Carrigtwohill URDF Initiative Urban Expansion Area (UEA) Infrastructure Bundle Part 8 Report of Chief Executive

**Housing Infrastructure Implementation Team
Planning Directorate
September 2023**

Planning & Development Act 2000 & Regulations 2001
(As amended)

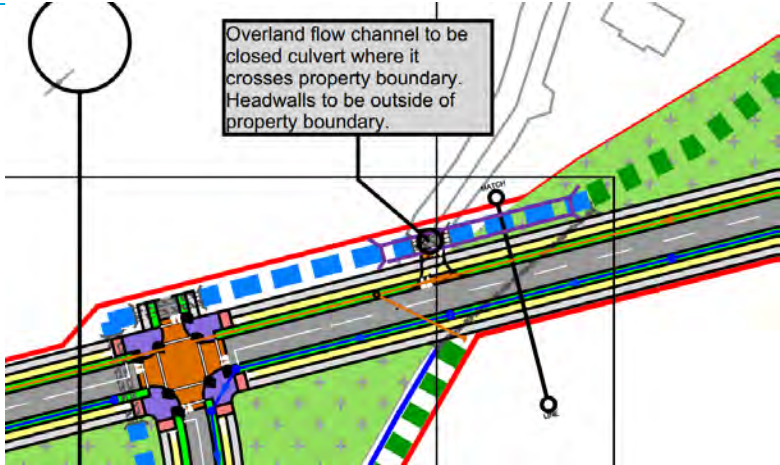
3	Anthony Barry	LAC532482019	<p>Issues Raised:</p> <p>This submission is very similar in content to LAC532493127 summarised immediately below.</p> <p>Chief Executive’s Response:</p> <p>See below response to LAC532493127 immediately below.</p>
4	Anthony Barry	LAC532493127	<p>Issues Raised:</p> <p>Generally, the submission is positive. The following concerns were noted in the submission.</p> <ol style="list-style-type: none"> 1. The proposed location of the attenuation pond within CT-GR-01 is noted as a concern. It is suggested that it should be located further to the east. 2. The submission notes concern about the lack of connectivity between the proposed scheme and the N25. It notes that the lack of connectivity to the N25 raises ‘serious concerns about the future viability of developing large sections of Carrigtwohill’ and that this needs to be addressed. <p>Chief Executive’s Response:</p> <ol style="list-style-type: none"> 1. The shared path will be re-aligned further east so that it is closer to the attenuation pond to allow for additional space for the public park – see drawing extract below. Furthermore, the layout of the attenuation pond will be reviewed at detailed design stage and revised to locate it further to the east within the redline boundary.

No.	Interested Party	Submission No.	Issues Raised and Chief Executive Response
			 <p data-bbox="712 954 2080 1409"> 2. The objective of CT-GR-01 in the Cork County Development Plan is “Open space, Provision of a Small Park West”. The attenuation pond would have potentially significant amenity and biodiversity value within the context of the “Small Park West” objective. </p> <p data-bbox="712 1058 2080 1193"> 3. Any required upgrade of the N25 would be undertaken by TII and is outside of the scope of this project. The new east-west services corridor is connected to N25 via the existing public road network (via the Carrigane Road at the eastern end) to Junction 4 (BarrysCourt). That connectivity to the N25 should continue subject to the final layout of the future N25 upgrade. </p> <p data-bbox="712 1201 2080 1305"> 4. The new east-west services corridor is also connected to the N25 at Junction 3 (Cobh Cross) via the existing public road network (via Wises Road). Connectivity to the N25 would continue (subject to the final layout of the future N25 upgrade). </p> <p data-bbox="712 1313 2080 1409"> 5. Part 8 planning for an interim upgrade of the N25 Junction 3 was approved in June 2022. This upgrade is currently being progressed through detailed design by Cork County Council. Traffic modelling completed as part of the Carrigtwohill Strategic Traffic and Transport Assessment, as referenced in the Part 8 planning </p>

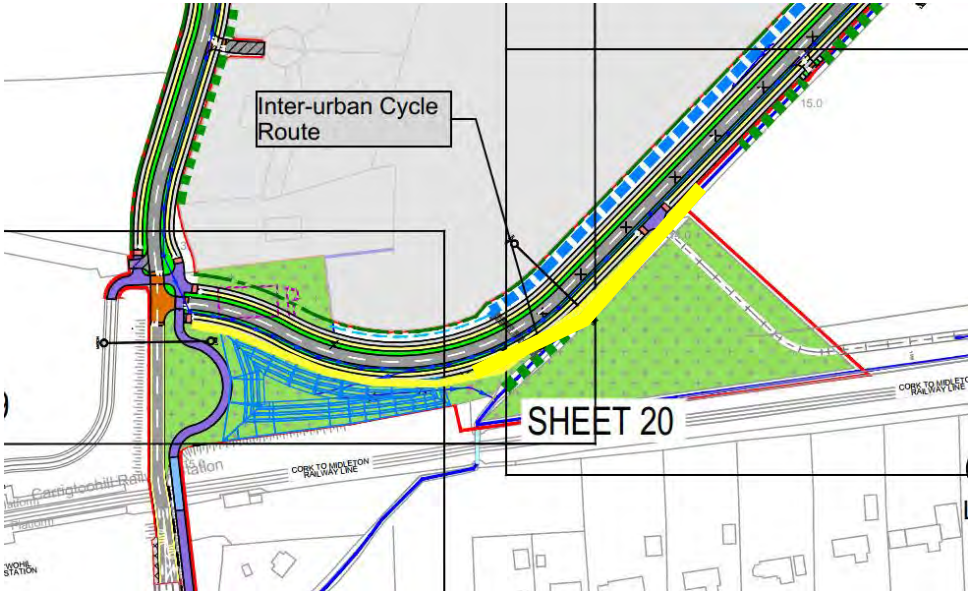
No.	Interested Party	Submission No.	Issues Raised and Chief Executive Response
			<div data-bbox="712 231 1496 758" data-label="Image"> </div> <p data-bbox="712 778 1048 810">Chief Executive’s Response:</p> <p data-bbox="712 869 2027 1045">The Strategic Housing Development (SHD) proposals referenced in the submission are currently part of an active planning application: An Bord Pleanála (ABP) is the deciding authority and permission has not been granted. This Part 8 planning process is an independent planning process. In preparation of the Part 8 proposals, regard has been had to the SHD proposals referenced in the submission. Cork County Council will seek to coordinate the Part 8 proposals with those of BAM Property Ltd.</p> <ul data-bbox="806 1061 2060 1268" style="list-style-type: none"> • There is an existing strategic trunk foul sewer crossing of the Midleton to Cork railway line in the location shown in the below figure (extracted from the Part 8 proposals) which is different to that assumed by BAM Property Ltd. during the preparation of its SHD plans. The location of this existing foul sewer infrastructure which crosses under the railway north to south has been established using detailed topographical survey information gleaned by CCC prior to commencement of this Part 8 planning process.

No.	Interested Party	Submission No.	Issues Raised and Chief Executive Response
			<div data-bbox="851 223 1411 590"> </div> <div data-bbox="851 598 1724 1029"> </div> <p data-bbox="801 1069 2060 1173">In addition, Cork County Council has made a pre-connection enquiry to Irish Water based on the use of this strategic trunk foul sewer rail crossing point location as shown in the Part 8 proposals and confirmation of feasibility of connection has been issued by Irish Water.</p> <p data-bbox="801 1212 1982 1284">Based on the location of the existing strategic trunk foul sewer infrastructure crossing under the railway line, no change is proposed to the trunk foul sewer layout in the Part 8 plans.</p> <ul data-bbox="757 1332 2049 1404" style="list-style-type: none"> • The route of the SW sewer which has been designed to drain the existing railway underpass structure by gravity will be revised locally to suit the SHD road layouts.

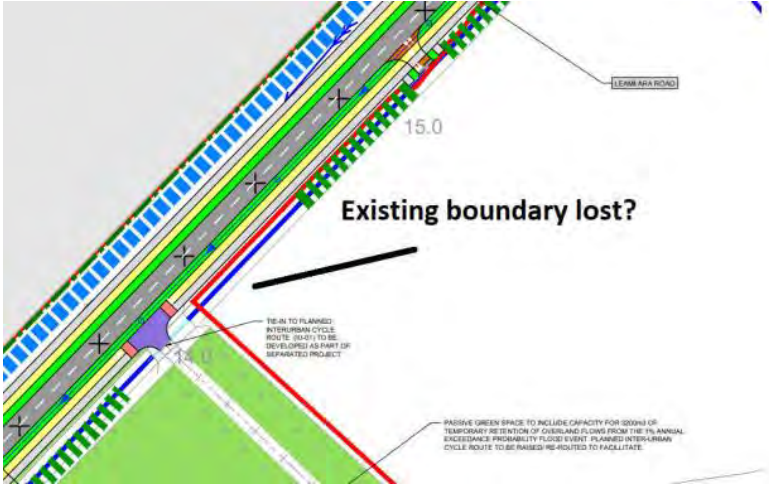
No.	Interested Party	Submission No.	Issues Raised and Chief Executive Response
			<p>4. The overall development of the UEA is outside of the scope of this Part 8. The proposed infrastructure will facilitate the commencement of development of housing, schools, and commercial areas within the Carrigtwohill UEA as per the Cork County Development Plan 2022 zoning and densities. The proposed infrastructure includes high quality segregated pedestrian/cycle facilities along the new/upgraded roads and numerous high-quality pedestrian/cycle links to the proposed inter-urban cycleway and to facilities within the existing settlement.</p> <p>5. Measures been applied within the road design to encourage/promote sustainable modes of transport throughout the UEA.</p>
22	Cllr. Alan O'Connor	LAC533470031	<p>Issues Raised:</p> <p>The submission gives general support for the objectives of the proposal whilst also commenting on various aspects of the design.</p> <p>Given the length of and detail included within this submission the Chief Executive's response has been provided on a point for point basis.</p> <p>1. Issue Raised:</p> <p>The submission queries the need for widening the Ballyadam Road and Station Road north of their junctions with the Eastern and Western Services Corridor Link Roads respectively. The submission states that these sections of roads are not required to provide access to zoned land. It is noted that the provision of these new sections of road would lead to higher costs and loss of existing trees and hedgerows. Whilst the pedestrian and cycle infrastructure on these roads is welcomed it is noted that they would lead to a dead end.</p> <p>Chief Executive's Response:</p> <ul style="list-style-type: none"> • The proposed road upgrades are in accordance with the County Development Plan zoning objectives (CT-U-15 and CT-U-20). The existing roads that are referenced have no footpaths, cycle facilities, are extremely narrow in places, acute bends and have limited visibility. The upgrades are required to provide safe use of these roads in the future for all users. The proposed pedestrian and cycle infrastructure along these upgraded roads would facilitate direct access/connectivity for cyclists/pedestrians from the immediately adjacent future UEA development. • Any loss of existing trees and hedgerows has been minimised through this Part 8 process and has been assessed as part of the Ecological Impact Assessment and mitigation applied. Circa. 5.5 hectares of passive green open space has been provided within these proposals the hedgerows that are removed would be replaced.

No.	Interested Party	Submission No.	Issues Raised and Chief Executive Response
			<ul style="list-style-type: none"> • Existing road network safety issues would be addressed through these upgrades and eliminating or significantly reducing the risk of accident/injury to vulnerable and other road users on these sections of the road network. • Delivery of these road upgrades within the context of the Urban Regeneration and Development funded Project would be the most cost-effective approach and these road upgrades would connect safely to the existing road network to the north where cyclists/pedestrians could continue their journeys along the existing rural road network as per the current situation. <p>2. Issue Raised: It is suggested that permeability measures for cyclists and pedestrians in all zoned lands should be provided as part of future developments in these lands.</p> <p>Chief Executive’s Response:</p> <ul style="list-style-type: none"> • This suggestion is noted. It is noted that this suggestion is in line with the objectives of the proposed development. <p>3. Issue Raised: The submission notes that it is the interpretation of the author that the proposals require the removal of the hedgerow on Station Road north of Greenville House on the east side of the road. It is stated that there are important natural hedgerow boundaries, mature trees, and boundary walls on the eastern side of Station Road. It is suggested that if the road upgrade is required that the road alignment should be moved to the west to retain the existing eastern boundary.</p> <p>Chief Executive’s Response:</p> <ul style="list-style-type: none"> • The Part 8 proposals are designed to ensure that widening will be entirely to the west so that no removal of hedgerow/ boundary walls/ mature trees on Station Road, north of Greenville House on the that side (east) of the road is required. <p>4. Issue Raised: The submission identifies an area on Ballyadam Road which could be used as passive green space – see below figure.</p>

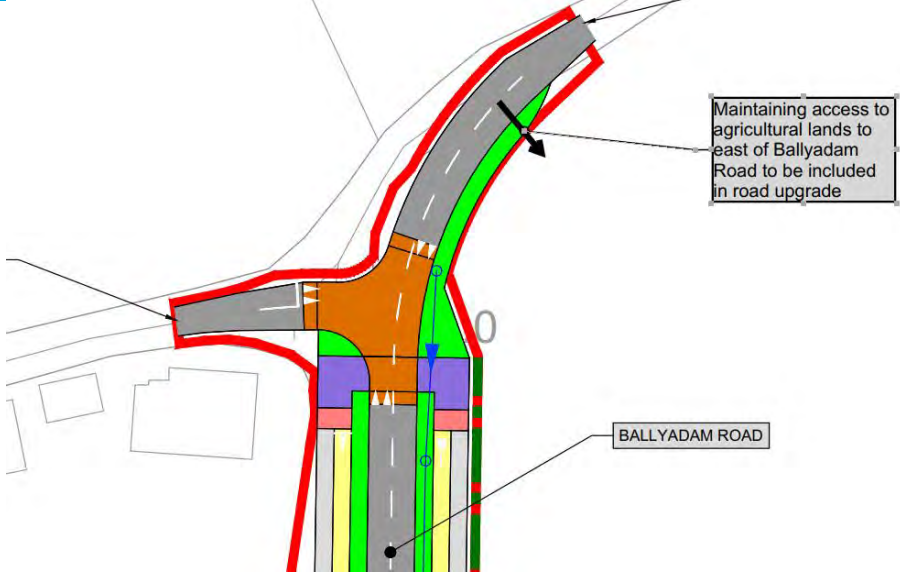
No.	Interested Party	Submission No.	Issues Raised and Chief Executive Response
			<p>12. Issue Raised: The submission queries if it is proposed to remove the below hedgerow on Leamlara Road and if so, queries if this is necessary.</p>  <p>Chief Executive's Response:</p> <ul style="list-style-type: none"> • The proposed upgrade of the Leamlara Road involves widening of the road way to the west (or full realignment to the west of the existing Leamlara Road). The hedgerow/Woodstock stream will not be impacted. The road widening will be entirely to the west so that there will be no removal of the section of hedgerow in question on Leamlara Road. <p>13. Issue Raised: The submission provides some suggested guidance for how the landscape design could be implemented as summarised below:</p> <ol style="list-style-type: none"> Hedgerows should mostly be comprised of locally native species (e.g., hawthorn, ash, blackthorn, elder, ash, oak, elm, etc.) and be grown on an embankment which provides a complementary habitat for the vegetation. Fastigate or 'Lollipop trees' are often selected for landscaping for their low maintenance. It is suggested that to achieve significantly greater benefits the vast majority of trees should be of locally native, and

No.	Interested Party	Submission No.	Issues Raised and Chief Executive Response
			<p>native species, with some few non-native or naturalised ornamentals and with a ‘focus on providing for maximum biodiversity return’.</p> <p>c. Landscaping should generally use locally native plant species which may not require much ‘active planting’. It is noted that planting larval food-plant, such as nettles, and not just ‘pollinator friendly’ species would be useful. It is also suggested that the landscaping component should not comprise a straight-line-and-active-planting approach i.e., the use of annuals which would require re-planting every year. It is suggested that open space areas may benefit from passive intervention rather than active planting.</p> <p>d. It is noted that no plastic membranes should be used for weed suppression. The submission presumes that no plastic will be used in the creation of surface water ponds and that gravel/stone chippings should be avoided as a landscaping substrate.</p> <p>e. It is noted that it is important water courses are above ground as much as possible.</p> <p>f. For any landscaping proposals associated with this project, artificial light should be kept to a bare minimum, if deemed necessary at all.</p> <p>Chief Executive’s Response:</p> <ul style="list-style-type: none"> • Each of the above suggestions is generally in line with the objectives of the proposed development and will be considered for implementation during the detailed design phase of the project (subject to planning). • All trees, hedgerows, planting will be specified by a Landscape Architect based on advice from project ecologists. • Artificial lighting of passive open space, if any, will be kept to an absolute minimum. <p>14. Issue Raised: It is requested that the loss of stone walls and built heritage should be minimised. The construction of new wall sections and/or structures should take a sensitive approach and be designed to be the ‘heritage structures of tomorrow’.</p> <p>Chief Executive’s Response:</p> <ul style="list-style-type: none"> • The removal of stone walls and field boundaries has been minimised throughout the design. The removal of some sections of field boundaries, some of which include sections of townland boundaries, has only been proposed out of necessity. The removal of these boundaries has been assessed in the Archaeological and As-Built Heritage Impact Assessment Report. Whilst none of these boundaries are designated of
